RIVER DODDER GREENWAY

SUBMISSION BY DODDER ACTION

OPTIONS ASSESSMENT AND PRELIMINARY DESIGN

Dodder Action (DA) proposals for Dodder Greenway Routes and Paths between Templeogue and Ringsend with reference to Feasibility Study Report (FSR) proposals.

Fig. 42 DCC: River walk between the Packhorse Bridge (to left) and Milltown Bridge

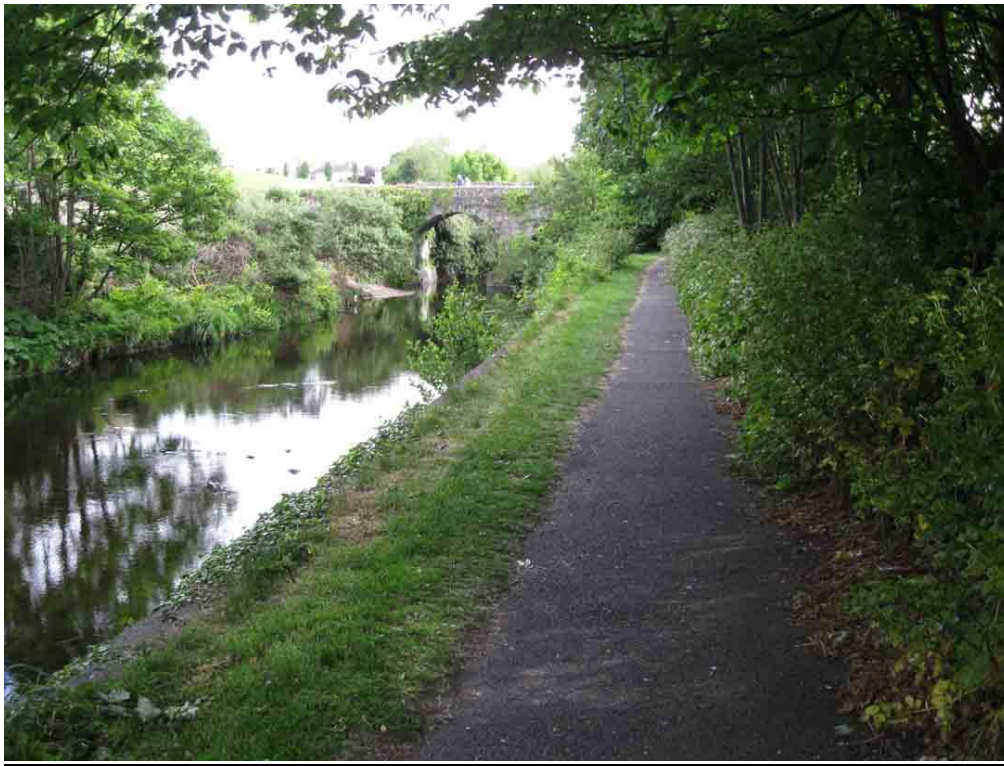
FSR Design: The 4 m stick indicates that the design path would occupy half of the existing total width of 8 m between the river wall and the railings of the apartments. Given that this will be narrowed by a flood wall proposed along the railing side, the design path would turn this into an urban roadway. Lighting is unnecessary as there is sufficient ambient light, and as unsuitable for habitat.

Existing path should be retained as is: It is used intensively. It is of high visual and heritage amenity and unique landscape character and runs along the top of a stone river wall. There are mature trees and hedgerow to right, with view to mature trees and habitat on the opposite riverbank. It is wide enough for pedestrians and other uses.

Fig. 43 DLR: River walk from Classon's Bridge to Packhorse Bridge

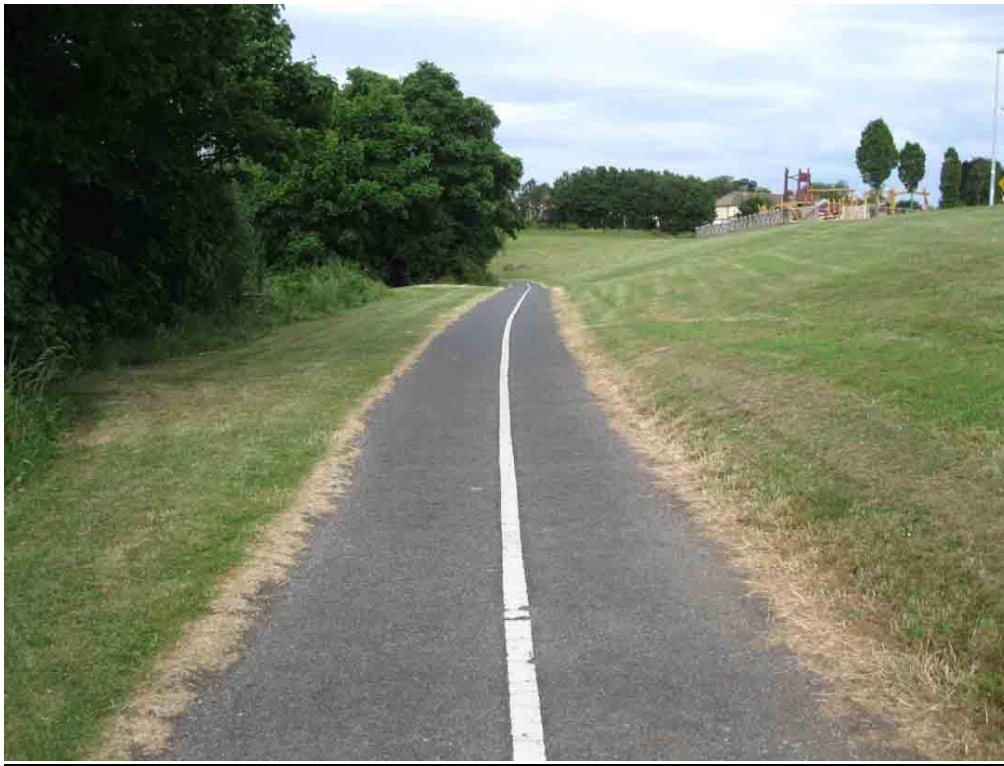
FSR Design: The 4 m stick indicates that the design path would result in major loss of trees and habitat and unique visual amenity. Lighting is unnecessary as there is sufficient ambient light and unsuitable for habitat. Railings are unnecessary and a visual obstruction. Proposed floodwall is along the road up to the right behind the trees, to conserve this unique pathway.

Fig. 44 DLR: River walk from Classon's Bridge to Packhorse Bridge

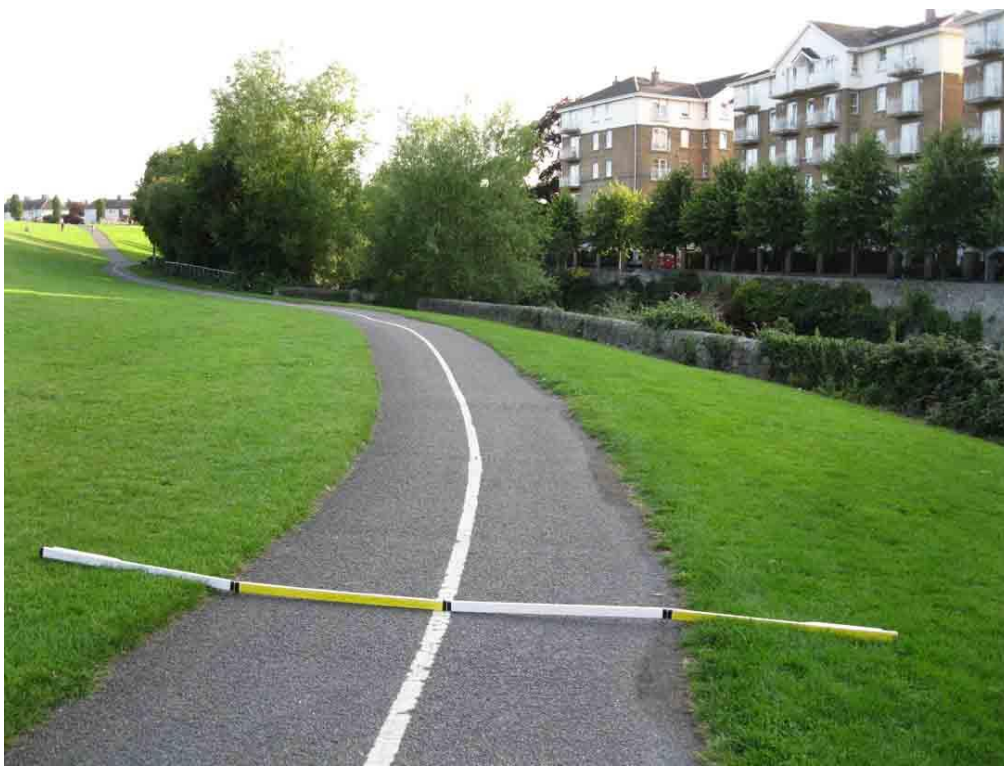
FSR Design: The 4 m stick indicates that an increase to 3.5 m width would provide space for a 2nd cycle lane. To protect the trees and bushes it should be widened sensitively into the slope on the right. Lighting is unnecessary as there is sufficient ambient light from Patrick Doyle Road, is unsuitable for habitat and lighting poles would be visually obtrusive.

Fig. 45 DLR: River walk between Milltown Bridge and Packhorse Bridge

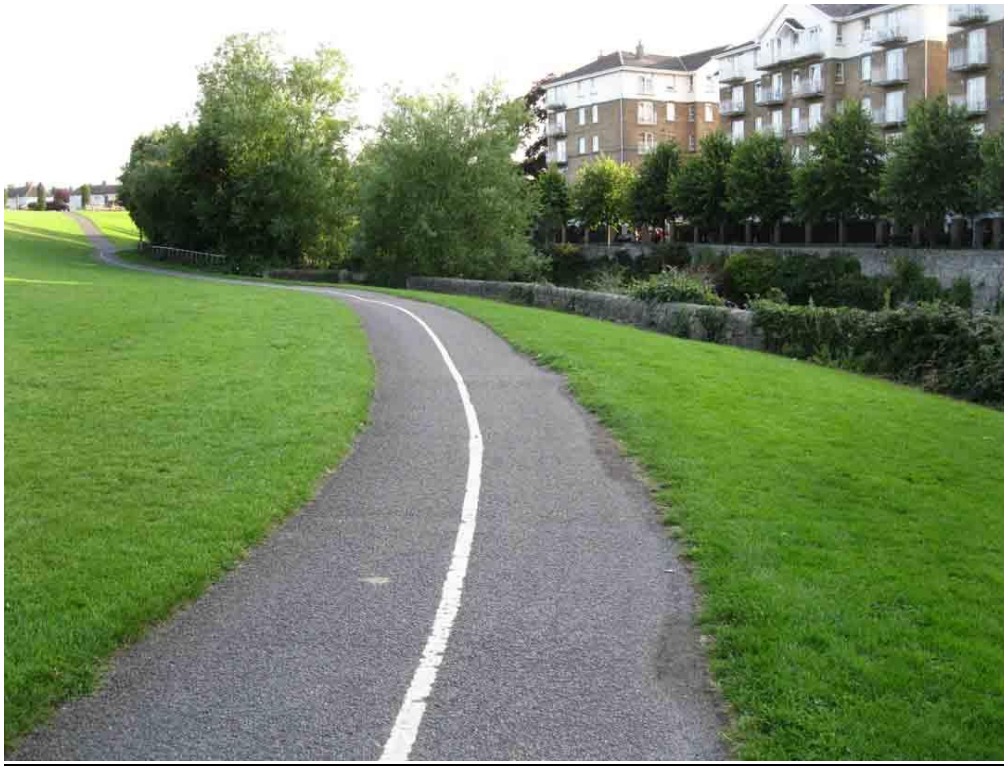
FSR Design: The 4 m stick indicates that an increase to 3.5 m width would provide space for a 2nd cycle lane. To protect the trees and bushes it should be widened sensitively into the slope on the left. Lighting is unsuitable for habitat and lighting poles would be visually obtrusive.

It is unnecessary as there is sufficient ambient light from Bankside Cottages and the road and apartment complex on the opposite bank.

Fig. 56 DLR/DCC: Stepping stones proposed at Milltown at historic Ford site
(Dodderbank across river, Milltown Green to right of path)

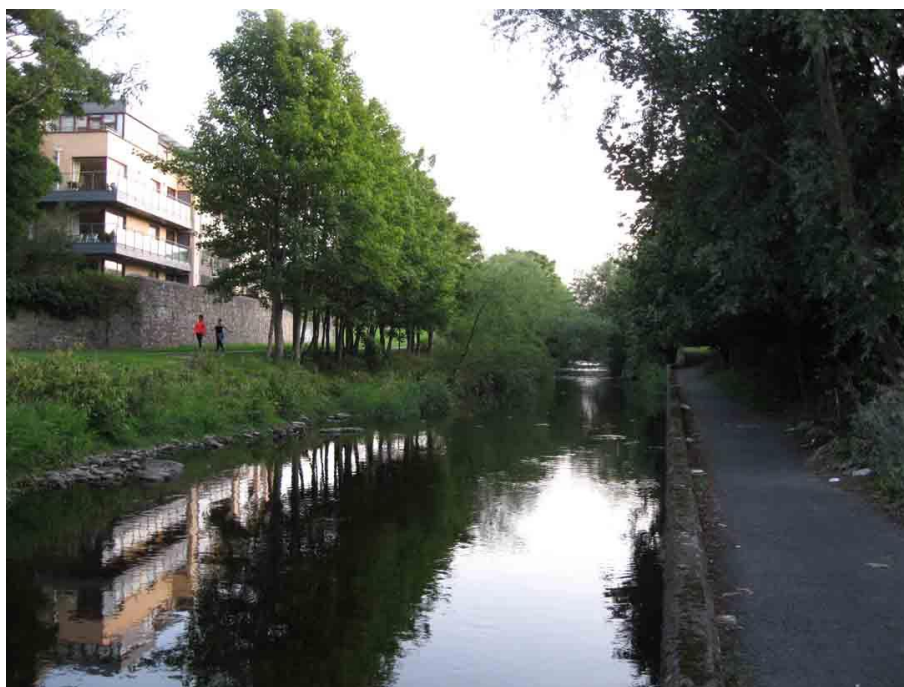
New Stepping Stones: It is proposed that a set of stepping stones across the river, similar to those at Bushy Park, be installed at the low wall behind the car park of Milltown Green. This was the historic crossing point or ford of the river (National Monument 022.093), for those wishing to avoid the toll in former times at the Packhorse Bridge, and would reproduce that facility. It would be negotiable only at usual shallow water levels.

Fig. 58 DLR: River walk between Clonskeagh Bridge and Aqueduct at river bend

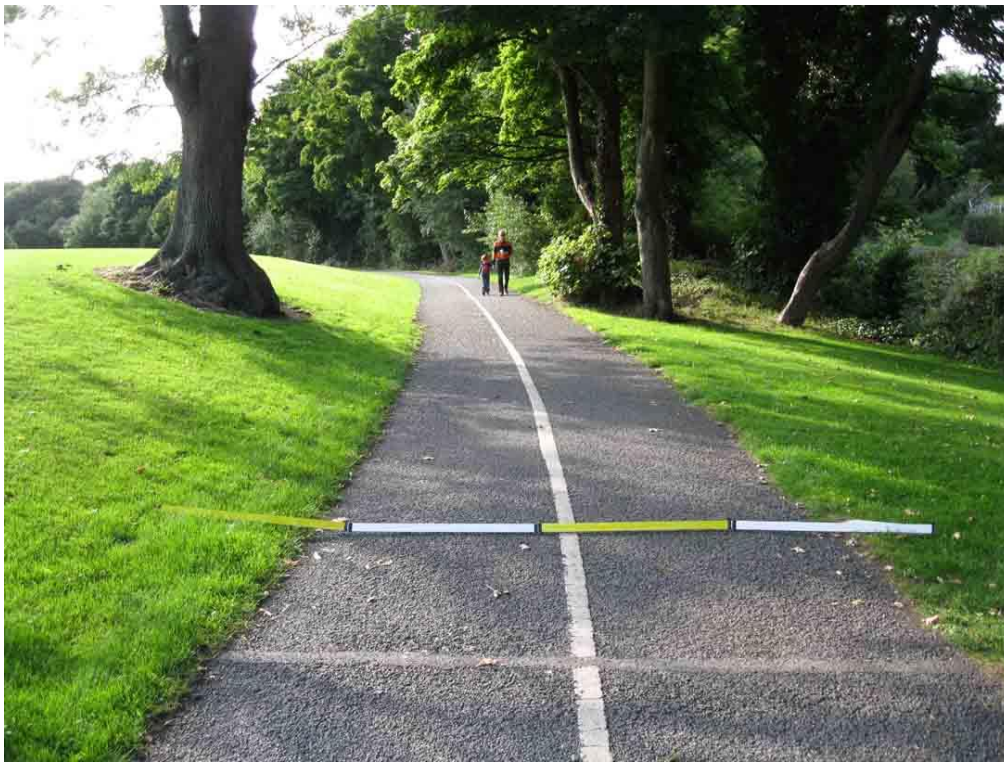
FSR Design: The 4 m stick indicates that the FSR design path and its 1-2 m margins would result in major loss of trees, habitat and heritage structures. This part of the river has never been lit on either side, and should remain as a 'dark corridor' for the benefit of bats, birds and other wildlife.

Existing path could be increased to 3.4 m width with minor works: It is of high visual amenity with views across grassland to the left, trees and riverbank to right. This grassland was previously the mill pond for the Iron Works, and is still soggy in winter. At 3.4 m width the path would provide for pedestrians and a 2-way cycle track.

Fig. 59 DCC: River walk along Scully's Field, from Strand Terrace to Clonskeagh Bridge

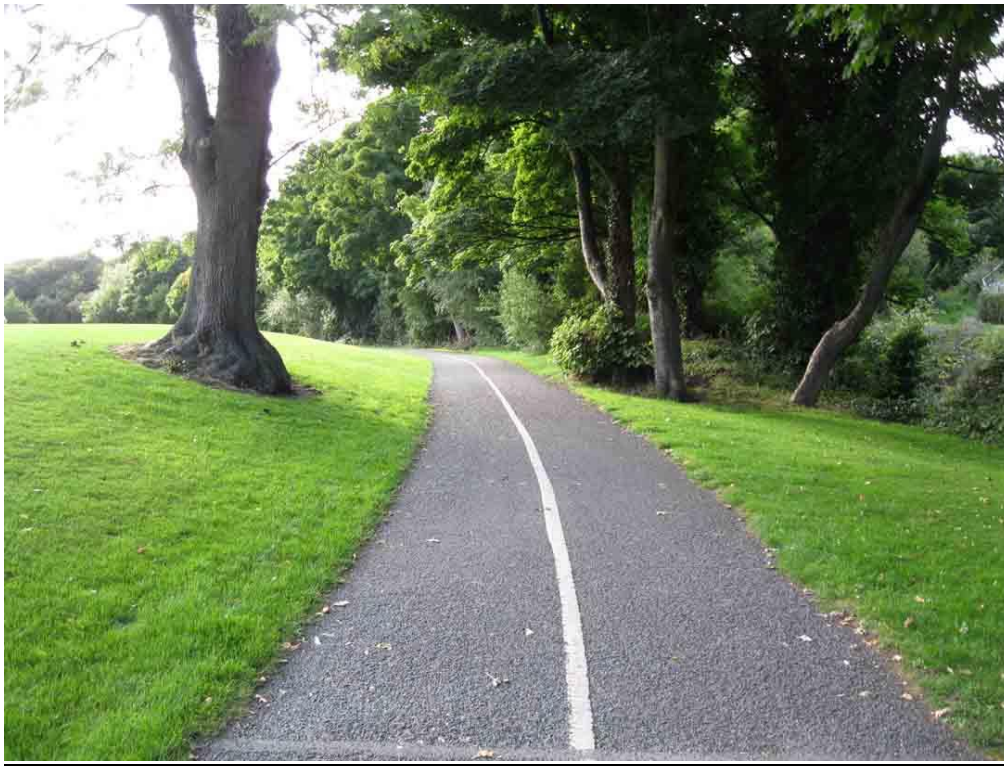
FSR Design: The 4 m stick indicates that FSR design path and its 1-2 m margins would result in major loss of trees and habitat. To protect the riverbank trees it should be widened sensitively into the slope on the left, but should narrow past tree on left. Lighting is unnecessary with ambient light from street lights on the far bank and Clonskeagh Road.

Fig. 75 DLR/DCC: Stepping stones proposed at Milltown below small weir
(Stones to be just below weir shown, there are existing steps up to path on bank to right)

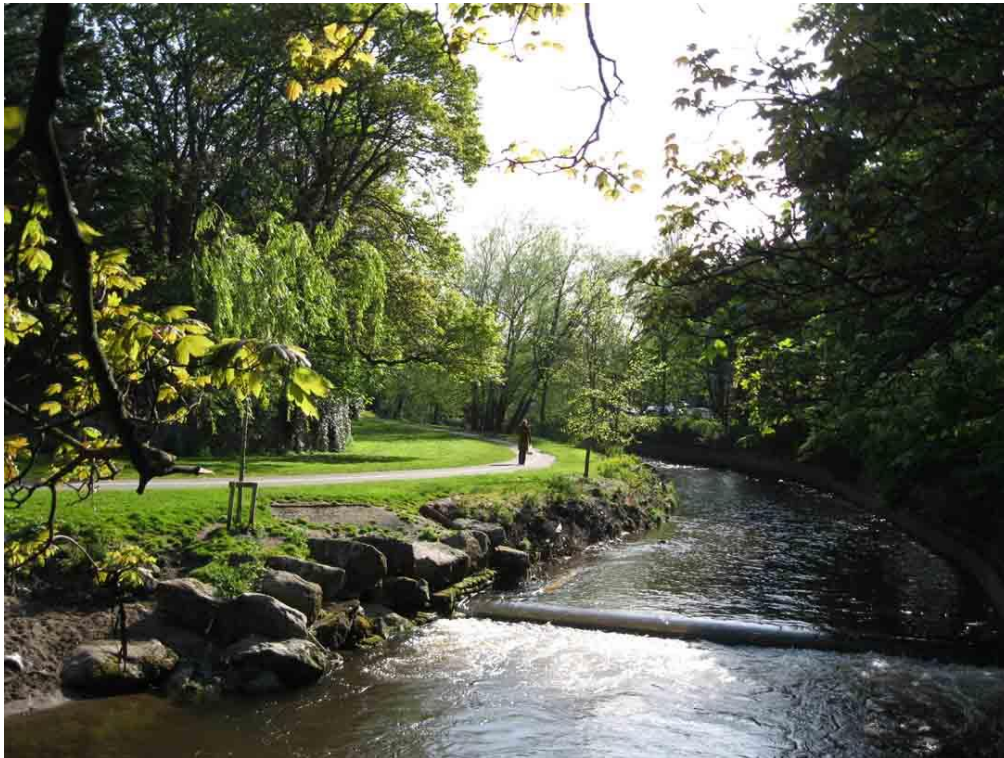
New Stepping Stones: It is proposed that a second set of stepping stones across the river be installed at Milltown, similar to those at Bushy Park. As shown in Fig. 75 below, they would be accessed from the far riverbank, and connect to existing steps up to the path alongside Scully's Field. This would provide added interest and connectivity for walkers and pedestrians. It would be negotiable only at usual shallow water levels.

Fig. 76 DLR: Steps down from Whitebeam Road onto path to be realigned

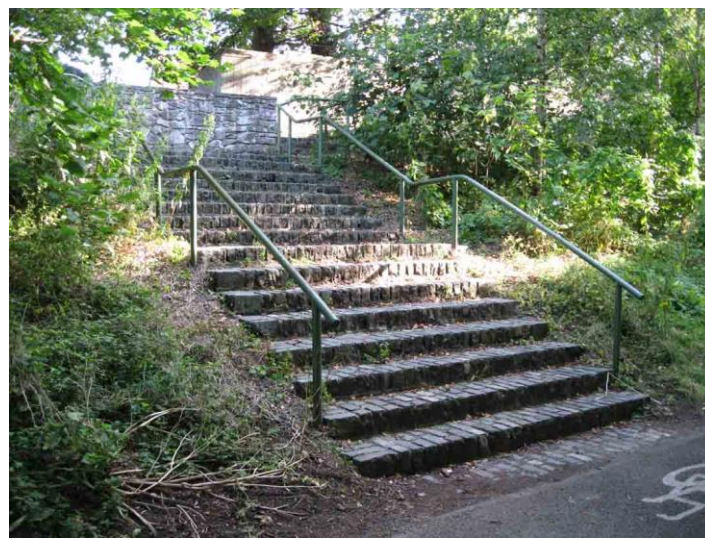
Reconfigure Steps from Whitebeam Road: There is a set of steps down from Whitebeam Road that opens directly on to the cycle path, and users may not see approaching cyclists. The lower section of the steps should be reconfigured, to remedy this safety issue. For example, the section could be rotated in direction by some 90⁰, (preferably upstream for minimum tree removal),

Fig. 82 DCC: Steps beside Ashton's from Clonskeagh Road to the weir

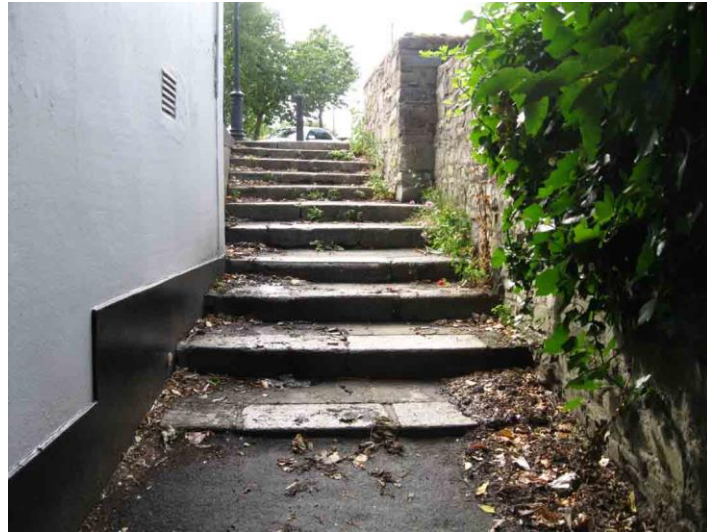
Stair-rails for steps at Ashton's: To facilitate connectivity for leisure cyclists and tourists, stair-rails (channels for bicycle wheels at side of steps – there are also twin-rail versions for buggies) could be installed on steps beside Ashton's down to the traditional path behind the weir. The slope should not be regraded but a handrail on the Ashton's side would assist.

Fig. 88 DCC: Path from Londonbridge via Fitzwilliam Quay to Ringsend Bridge

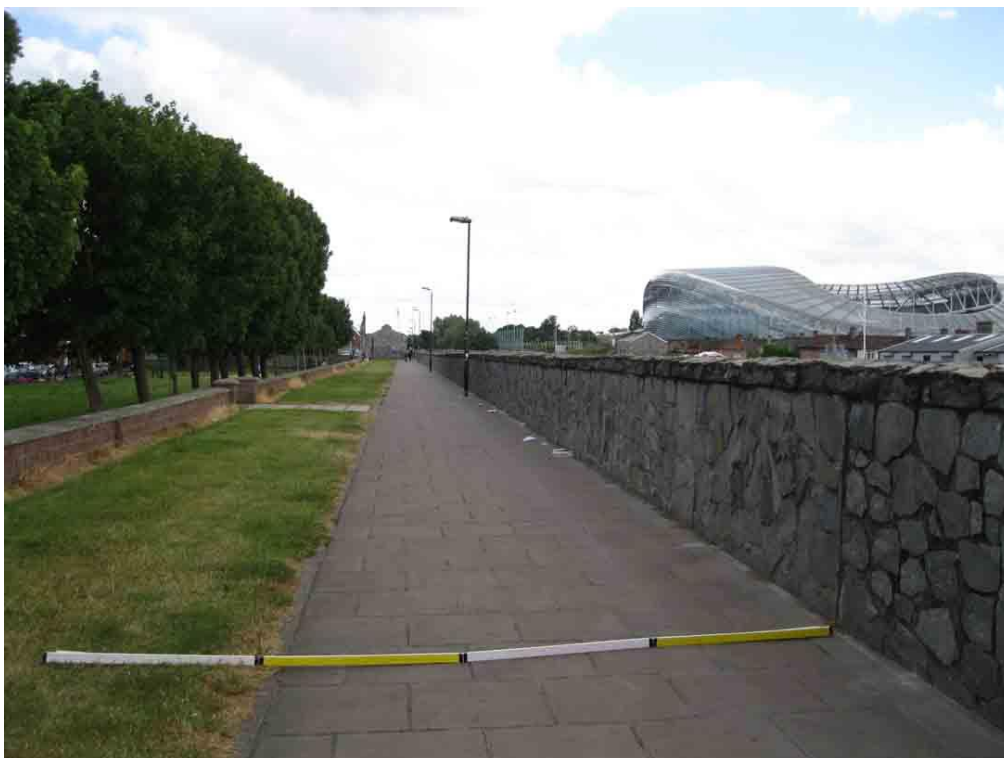
FSR Design: The 4 m stick indicates the design path is not feasible here. It is proposed that ‘through cycle’ route is on this side as more flexible and easier for users to bypass each other, The FSR proposes 4 m but would cause loss of habitat and amenity. Given that this is an off-road safer route, with natural amenity, any reasonable cyclists, commuter, tourist or leisure, will accept compromise and be prepared to give way to other users for this stretch, as in other places.

Fig. 89 DCC: Path along South Dock Road to Grand Canal Locks from Ringsend Bridge

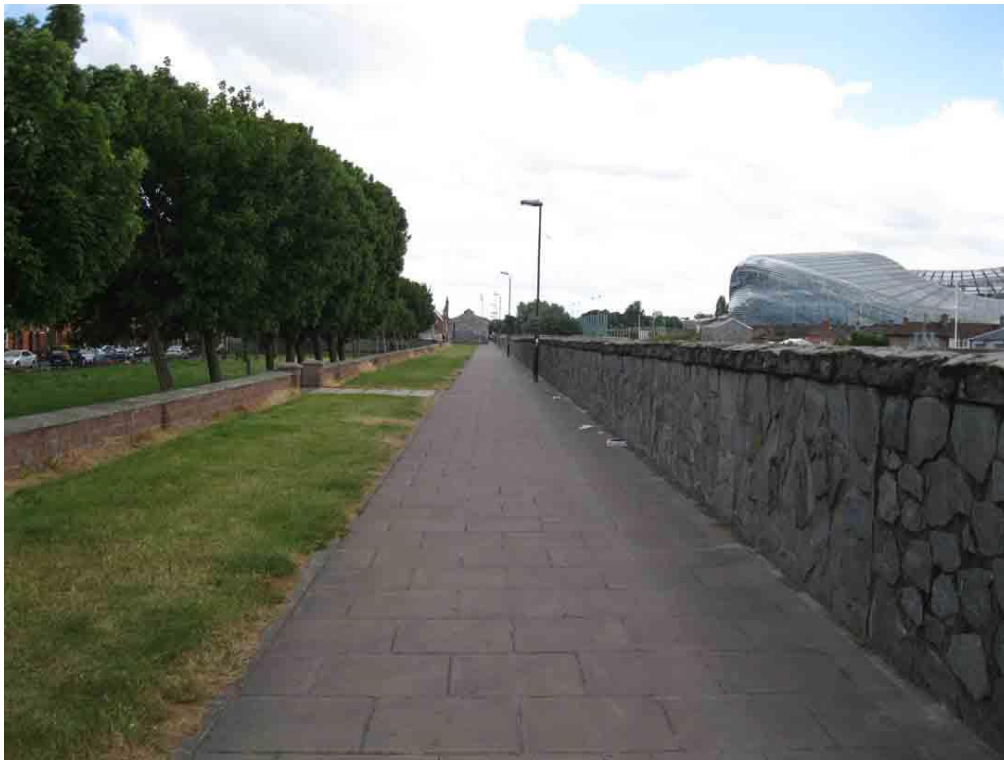
FSR Design: The 4 m stick indicates the design path is not feasible here without impinging on this community asset. The path is wide enough for two-way cycling and pedestrians to share.

Existing path to be upgraded as is: This path turns left at the end to the Locks. It could be of much greater amenity with resurfacing, planting of trees, and provision of wooden benches
